**AGENDA**  
**PLANNING COMMISSION MEETING**  
**Wednesday, February 3, 2021**  
**7:00 P.M.**  
Maggie Osgood Library  
70 N. Pioneer Street

- a. Land Use File 2019-04 – Sunset Hills Subdivision (Map 19-01-14-21, Tax Lot 05000)
  - Public Hearing
  - Commission Deliberation
  - Commission Decision

- a. Land Use File 2020-01—Tristan Ferguson Site Review (Map 19-01-14-22, Tax Lot 2301)
  - Public Hearing
  - Commission Deliberation
  - Commission Decision

CITY of LOWELL  
PLANNING COMMISSION  
RECOMMENDATION to  
CITY COUNCIL

**Attachment Q: Utility Plan – Sheet 2, Dated December 28, 2020**

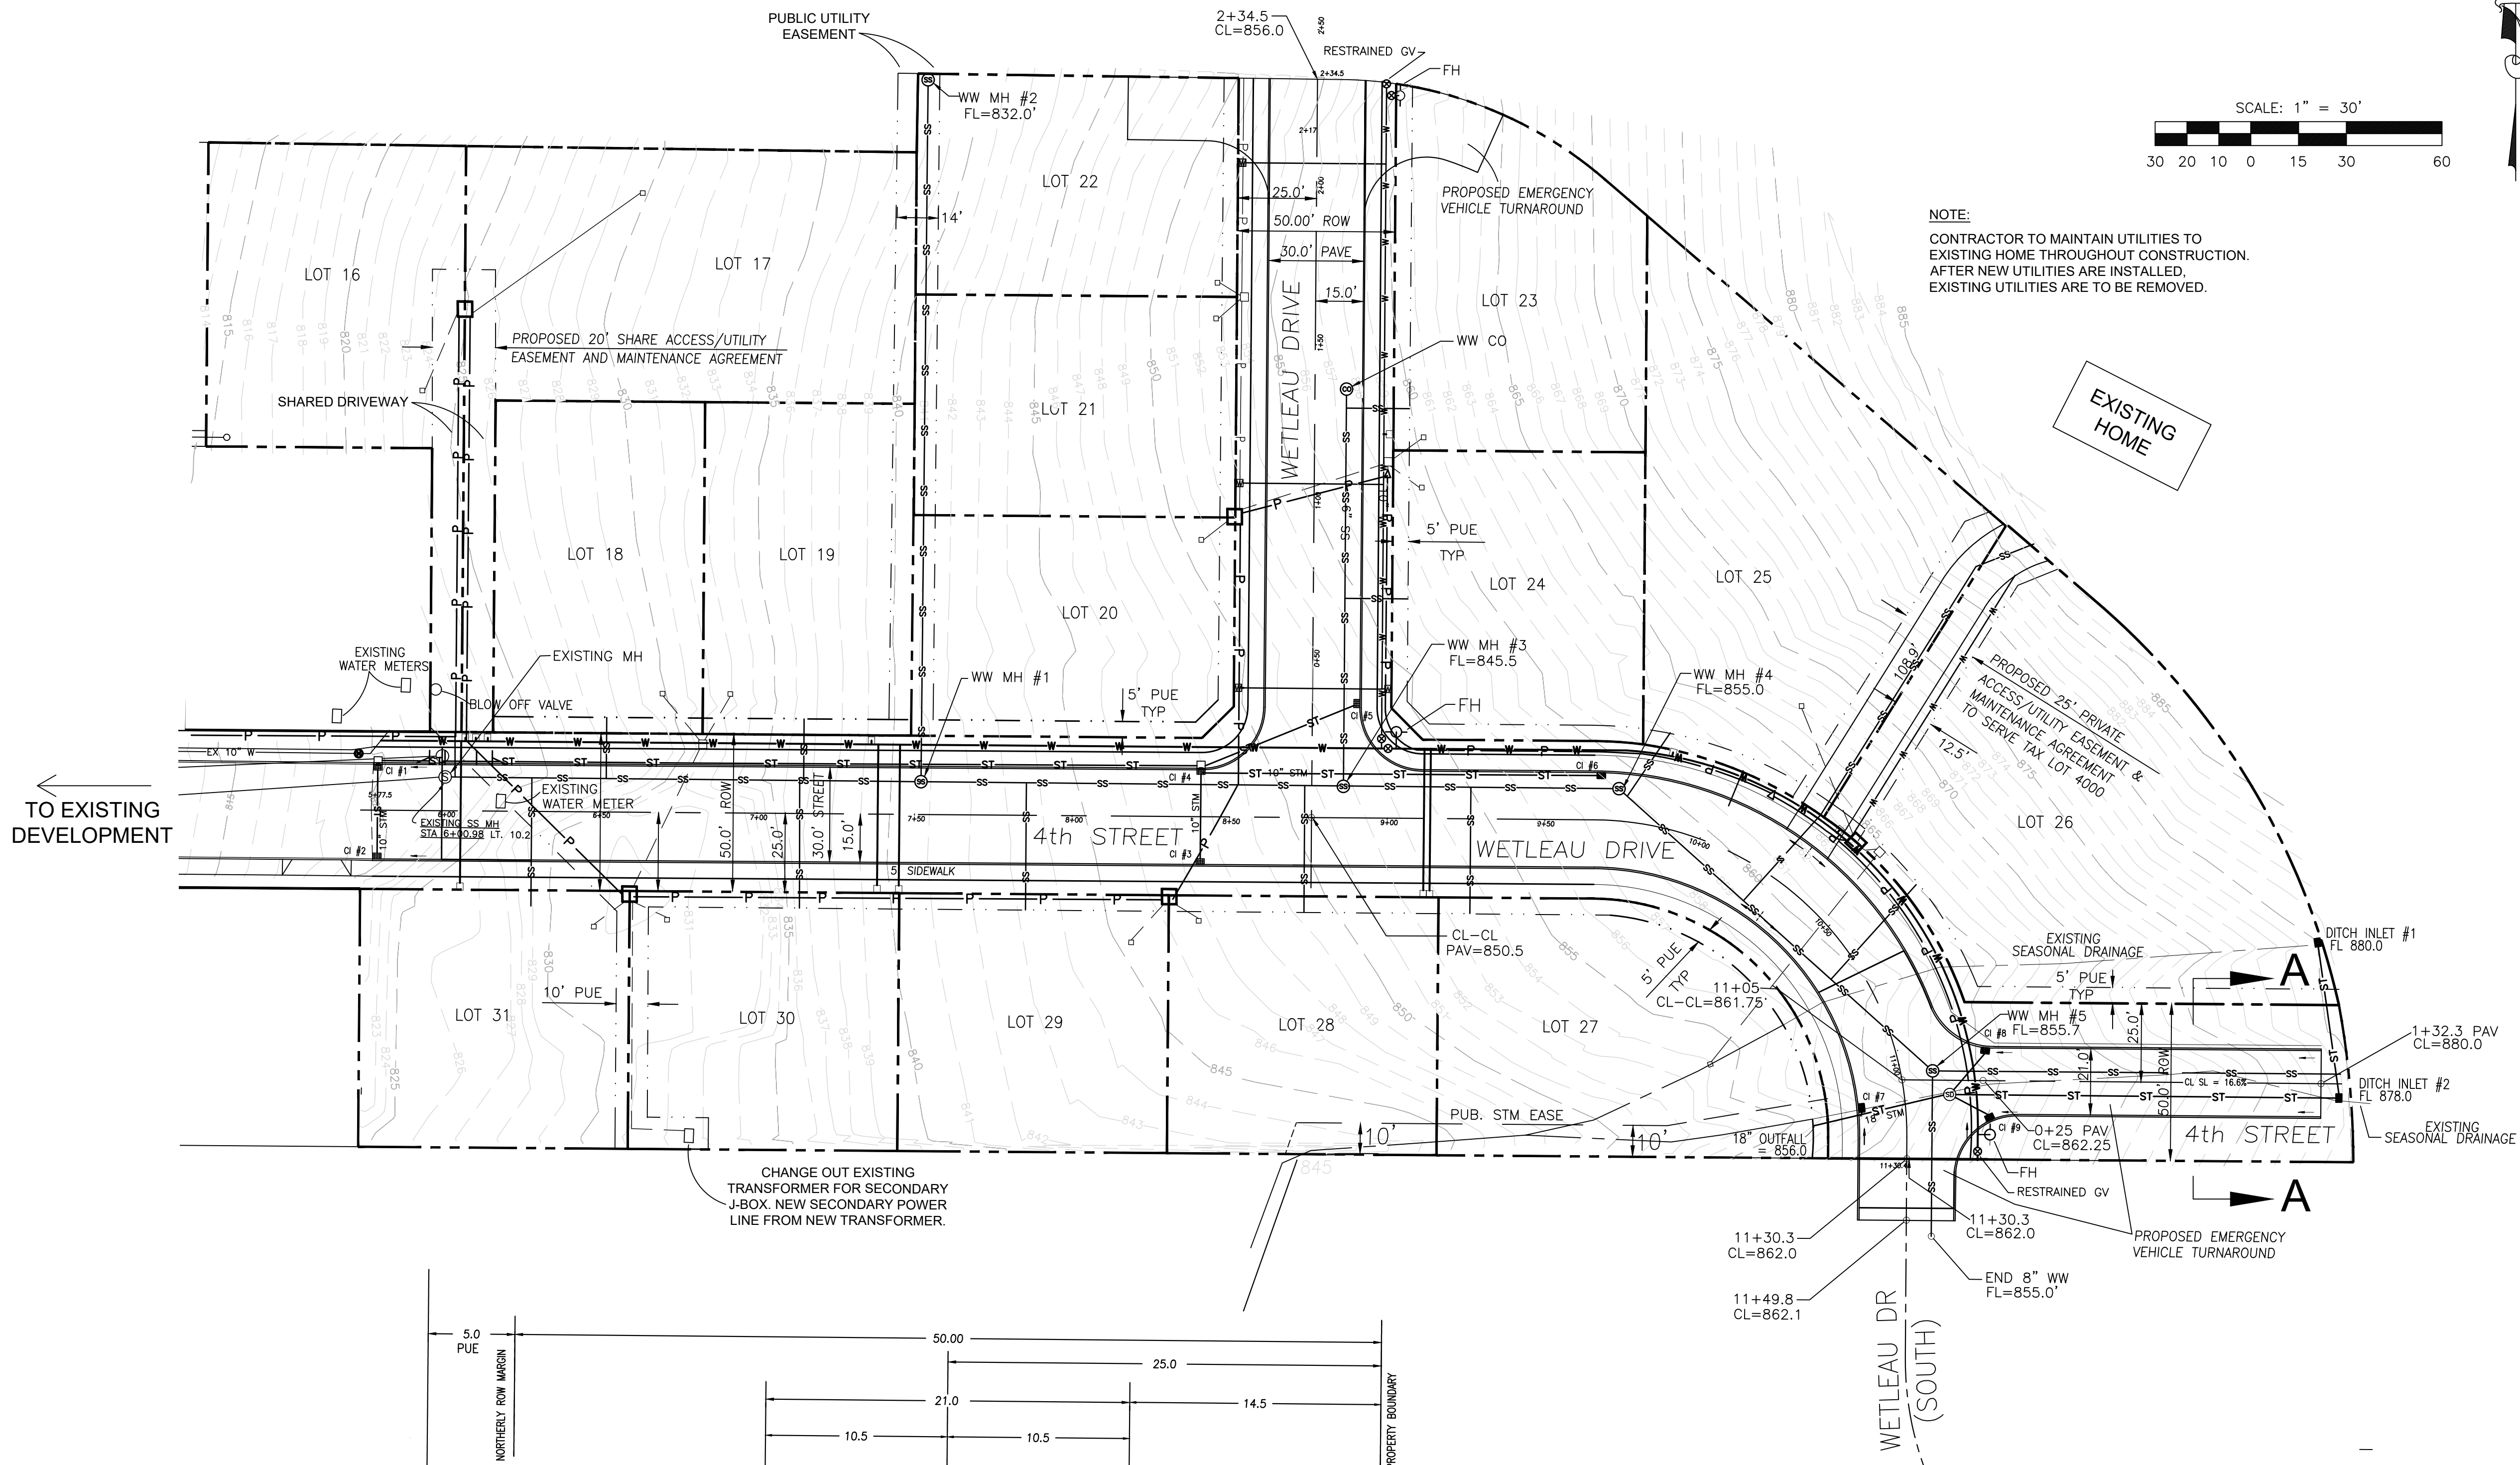
**Recommended FINDING for approval:** The site utilities plan as seen on Sheet 2, Dated December 28, 2020 is preliminary and provided for tentative map approval and revised Utility Plan, dated January 20, 2021. A final utilities plan shall be submitted for review and approval by the City Engineer prior to commencement of any construction activities with respect to water, sewer and utilities. Criterion met with the following Condition of Approval.

**Condition of Approval #18:** The utilities plan as seen on Sheet 2, and the January 20, 2021 Utility Plan, are ~~is~~ preliminary and for tentative map approval. A final utilities plan, consistent with LDC 9.521, shall be submitted for review and approval by the City Engineer prior to commencement of any construction activities with respect to water, sewer and utilities.

REVISIONS:  
 DATE: DECEMBER 15, 2020  
 DRAWN BY: CM  
 CHECKED BY: CM  
 PROJECT NO: 19-264  
 SHEET: **C3.0**

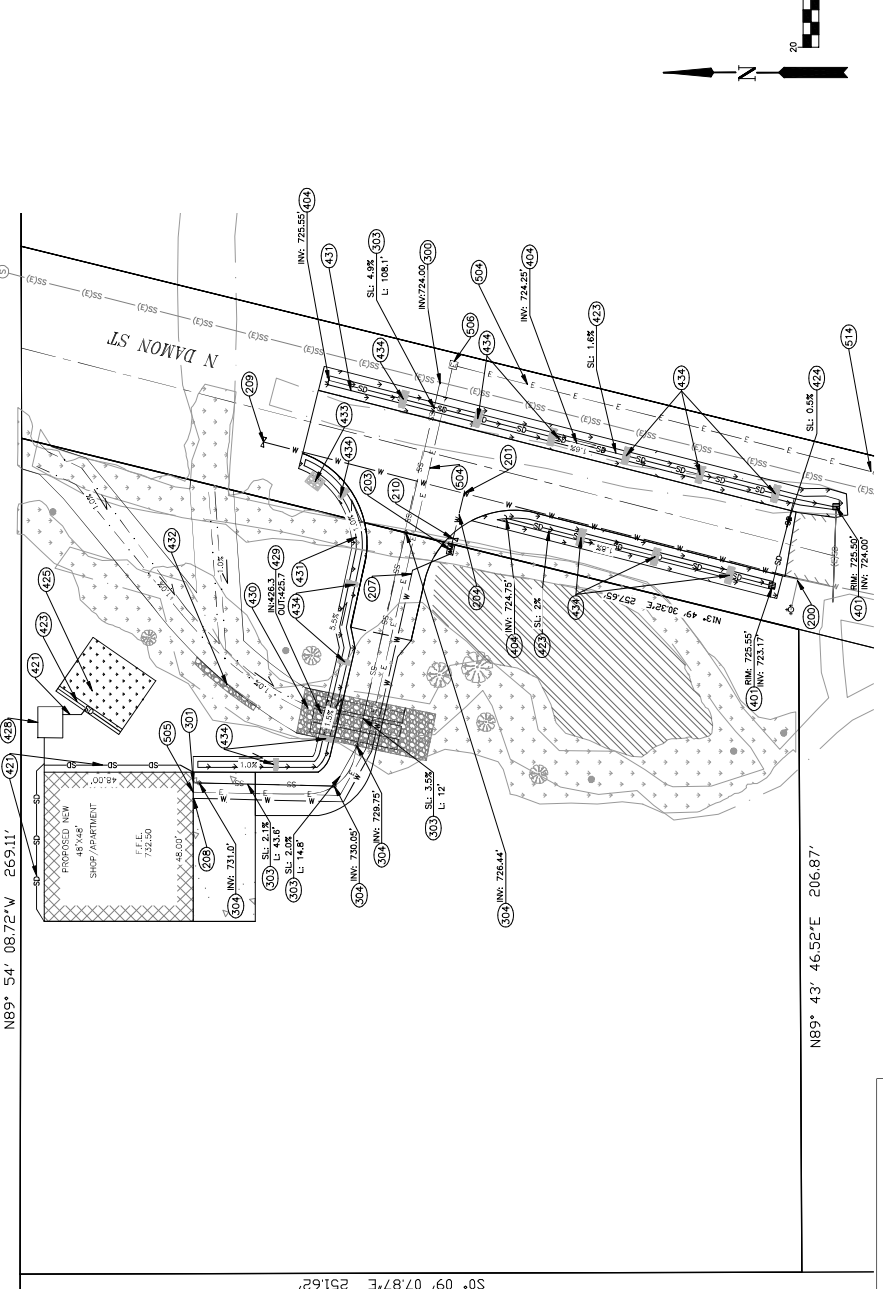
- ii. Provide grades of sewer lateral.
    - iii. Minimum slope of sewer lateral is 2% unless otherwise approved.
    - iv. Sewer lateral connection to existing sewer should be per City of Lowell Standard Detail 311 or 312 (depending on depth).

- v. Sewer lateral will be required to have cleanout at property line.
  - b. Water
    - i. Water service lateral & connection to main shall be per City of Lowell Standard Detail 407.

- ii. Draw existing system correctly. Per current drawing, it appears the main line is being connected to a fire hydrant.
    - iii. Adjust water main to be ~10' west of ROW centerline (within street section). Identify material and standard trench details, including backfill. Add reference to City Standard Detail 401 for thrust blocking.

- iv. Install blow-off per City of Lowell Standard Detail 404 at north end of watermain.
    - v. Add note: "All materials which are in contact with potable water shall be NSF approved".

- iii. Minimum slope of sewer lateral is 2% unless otherwise approved. *Slope is 2% minimum.*
    - iv. Sewer lateral connection to existing sewer should be per City of Lowell Standard Detail 311 or 312 (depending on depth). *Callout to detail was added to plans.*

- b. Water
  - i. Water service lateral & connection to main shall be per City of Lowell Standard Detail 407. [Callout to detail was added to plans.](#)

- iii. Adjust water main to be ~10' west of ROW centerline (within street section). Identify material and standard trench details, including backfill. Add reference to City Standard Detail 401 for thrust blocking. [The connection to existing main was moved to where it is thought to be within Damon St. ROW. Callout to detail was added to plans.](#)

- iv. Install blow-off per City of Lowell Standard Detail 404 at north end of watermain. [Callout to detail was added to plans.](#)
  - v. Add note: "All materials which are in contact with potable water shall be NSF approved". [Note was added to utility plan.](#)
